1411 South Potomac • Spec Suite 140

City of Aurora Building Division  
Reviewed for Code Compliance  
Approved as Noted: William Griffin  
Date: Dec 23, 2019  
2015 INTERNATIONAL CODES & 2017 NEC

RSN: 1426505  
Permit #: 19-1741436 LT

Issued On: 23 Oct 2019  
Issued For: Tenant Review & Approval, and Construction

Sheet: Egress Plan  
Contents: Project # 426009, Proj Mgr: GBS, Designed by: JMB, Drafted by: JMB, Checked by: GBS

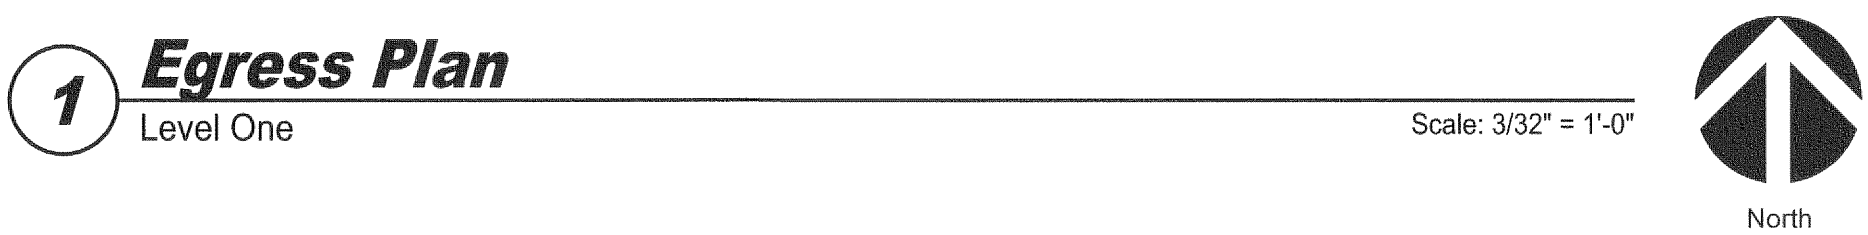
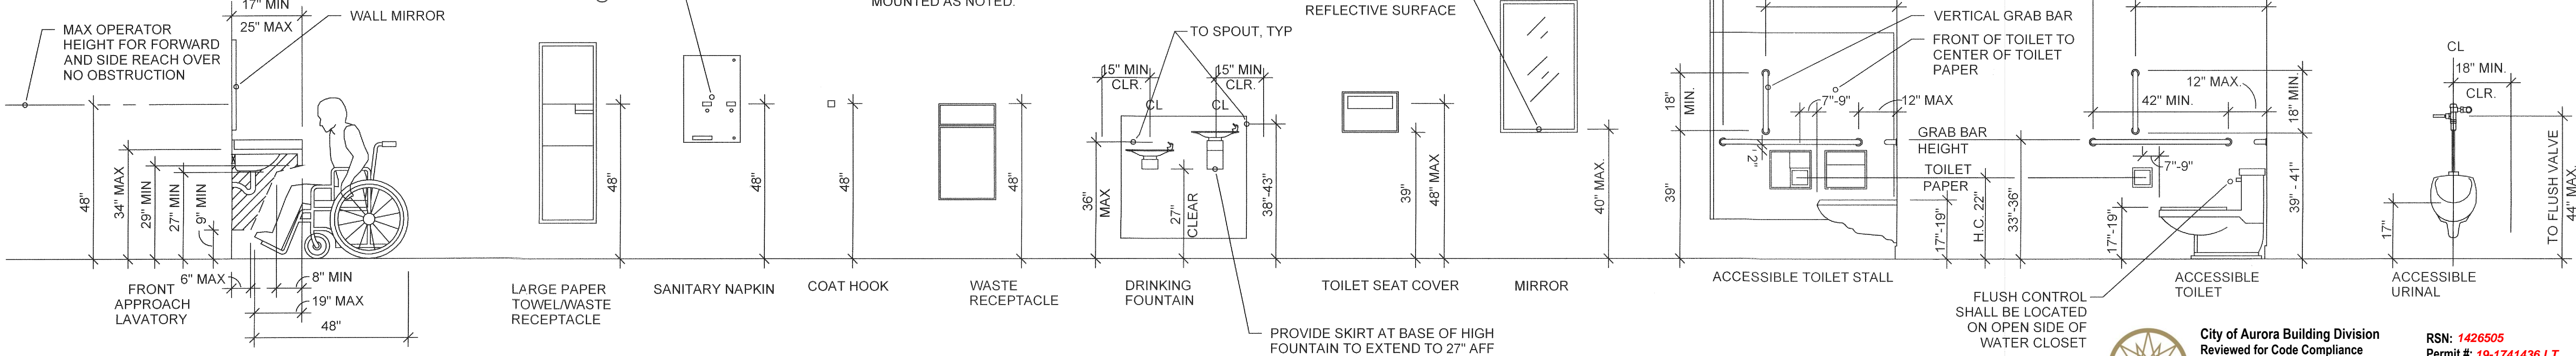
Provide a sign stating "EXIT" in raised, visual characters and braille adjacent to each door in an area of refuge, an exterior area for assisted rescue, an exit stairway or ramp, an exit passageway and the exit discharge. **2015 IBC 1013.4**

Provide U.L. Class **2A10BC** minimum rating fire extinguishers at a maximum 50'-0" travel distance prior to the Certificate of Occupancy issuance **2009 IFC Table 906.3(1)** and **2007 NFPA 10**

Provide lever or other approved hardware  
on all new or relocated doors.  
2003 ANSI A117.1

PLUMBING PLAN

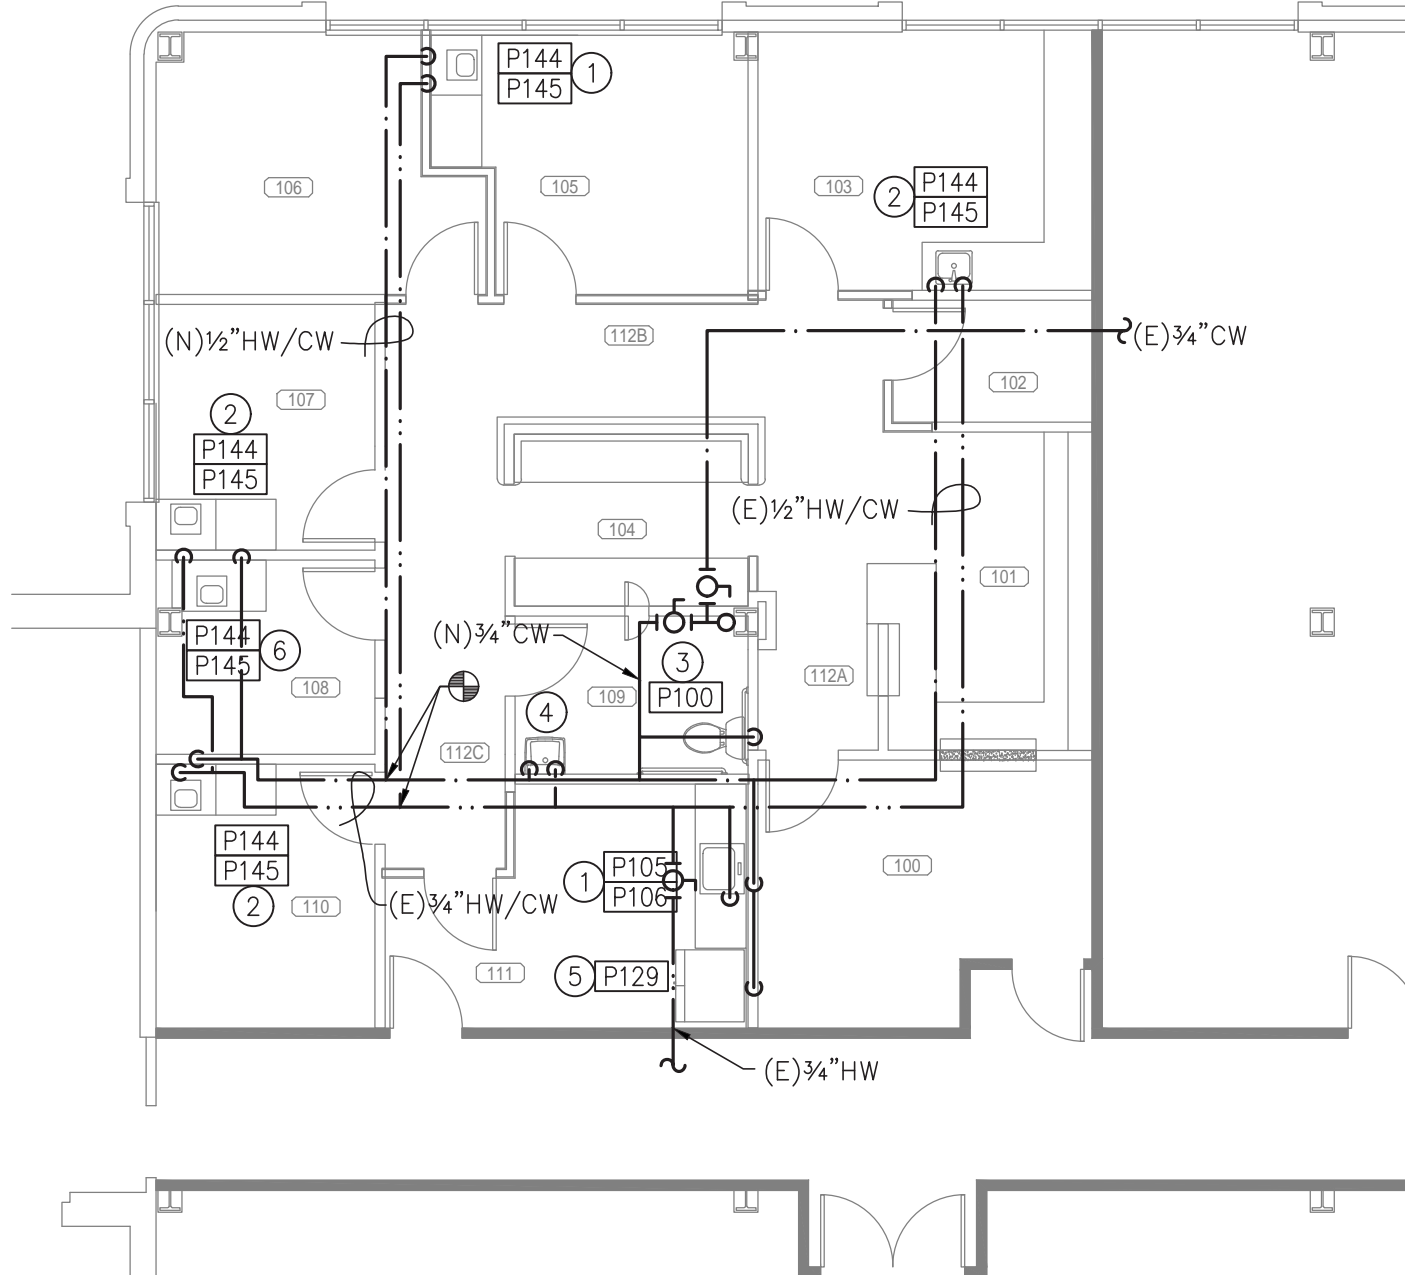
Provide self-closing or metered faucets in public restrooms.  
2015 COA 22-326 (a)

2 PARTIAL PLUMBING ISOMETRIC  
P2.0 SCALE: NTS

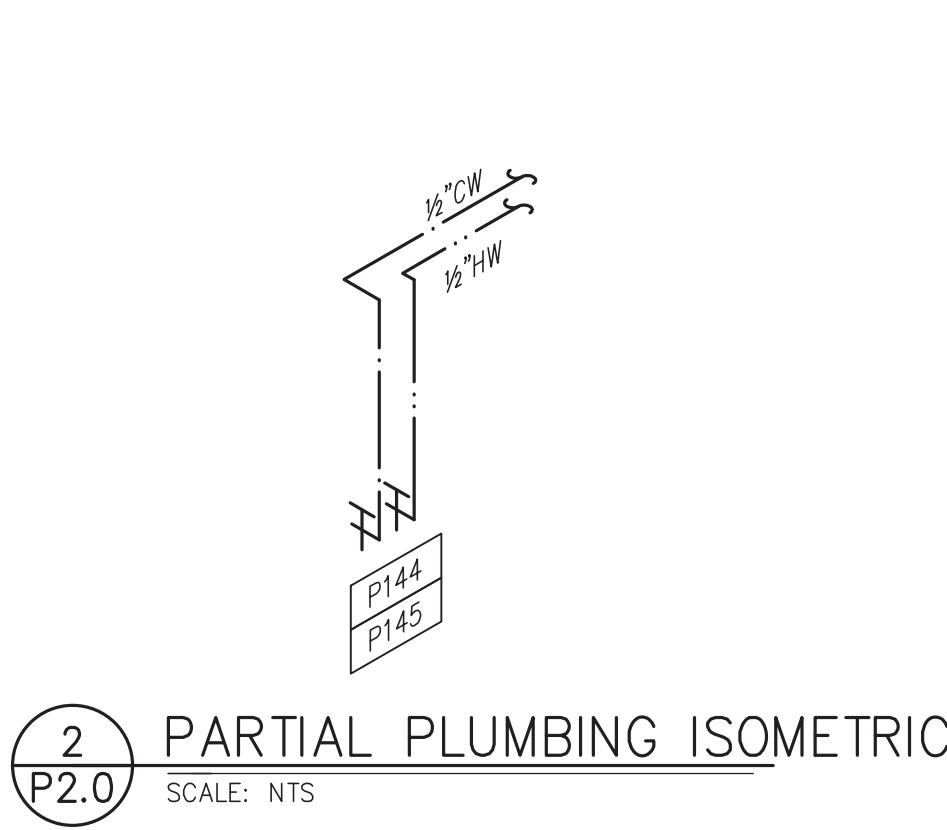
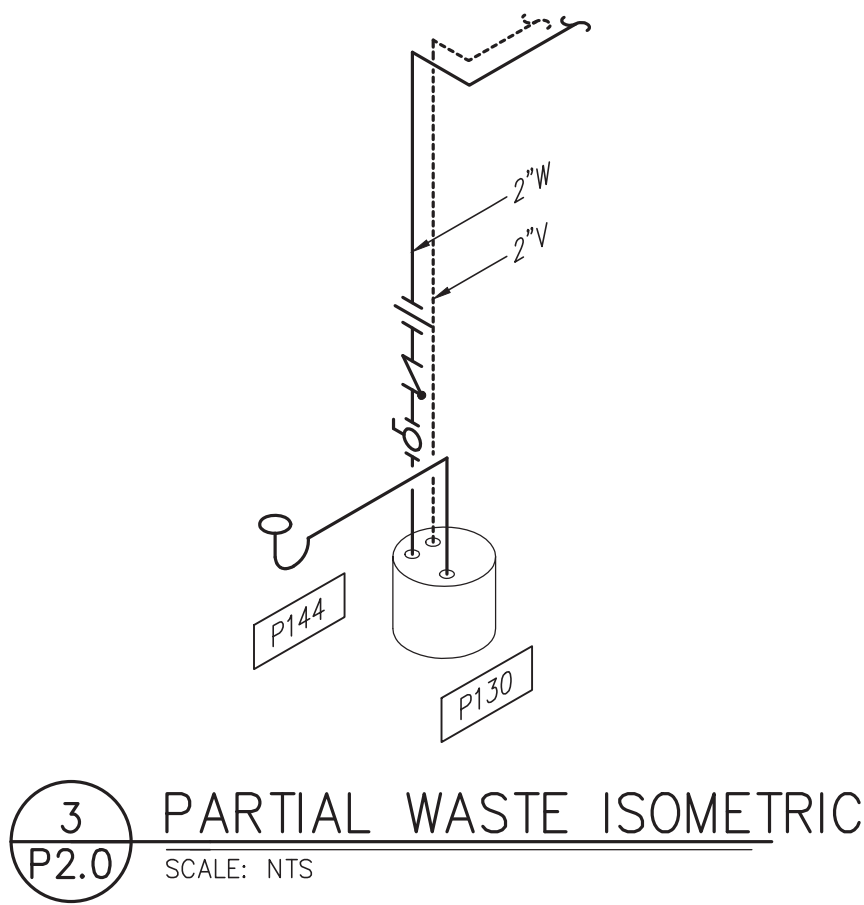
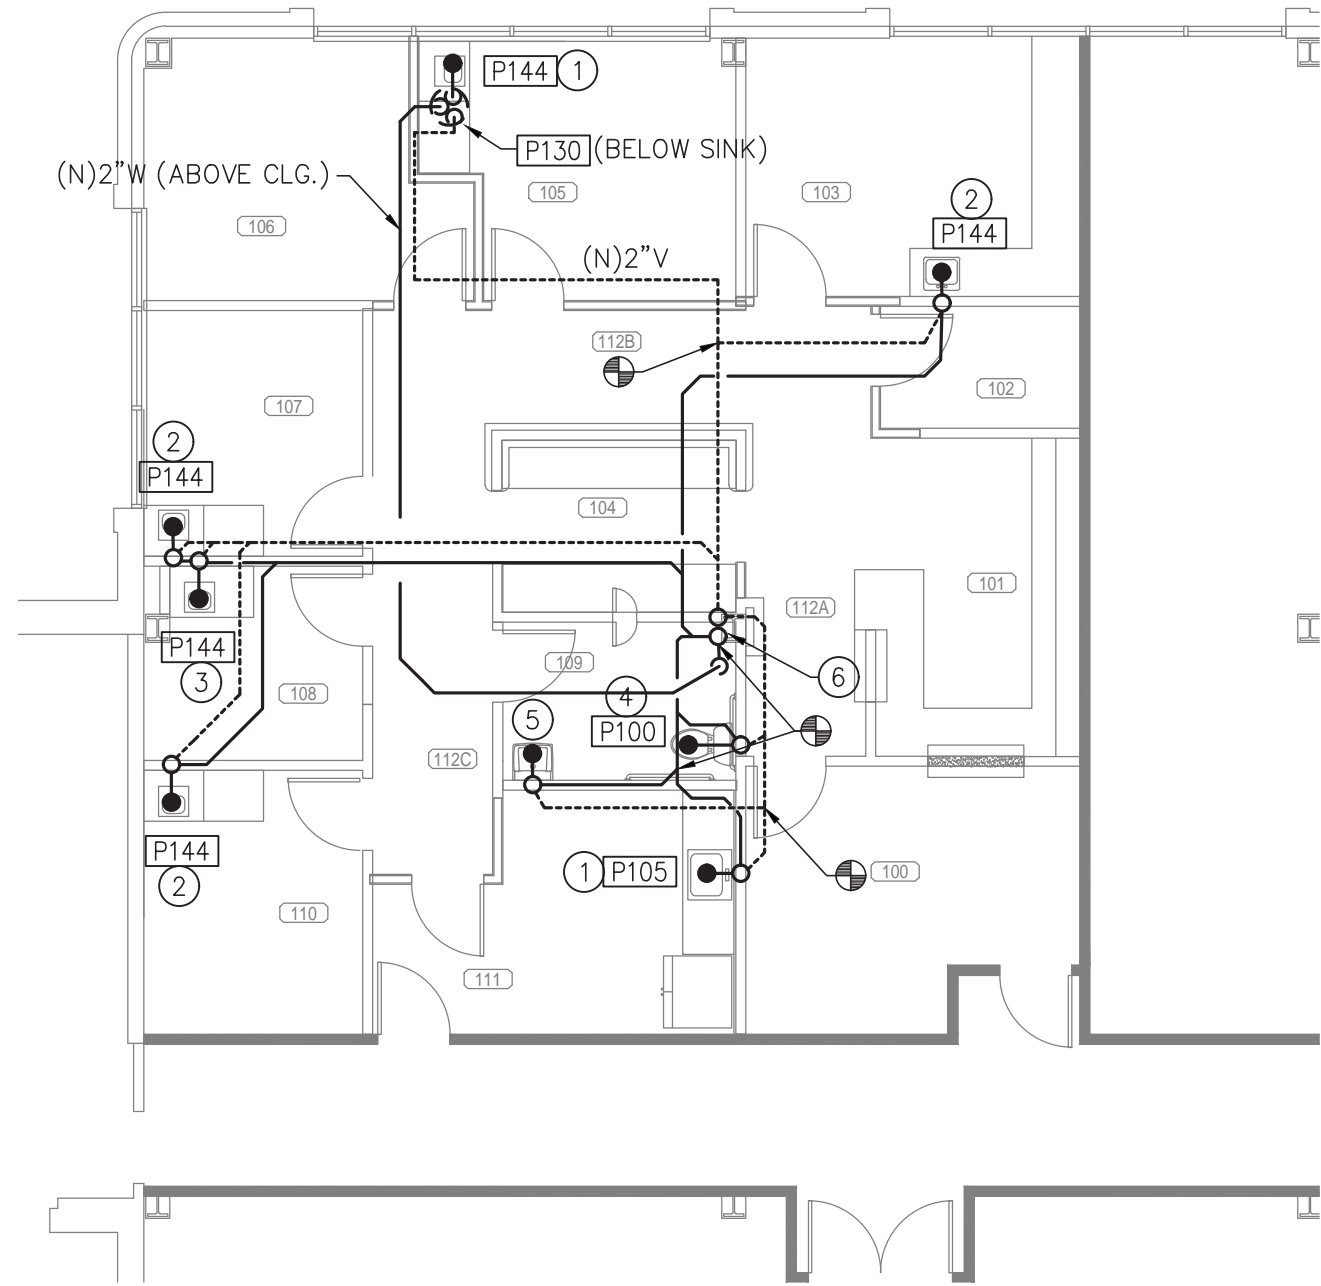
Provide self-closing or metered faucets  
in public restrooms.  
**2015 COA 22-326 (a)**

Provide drains no smaller than allowed  
by **2015 IPC 709.1 and 710.1(1)**

The dry vent must rise 6" vertically  
above the flood level rim of the highest  
trapped fixture being vented.  
**2015 IPC 905.4**
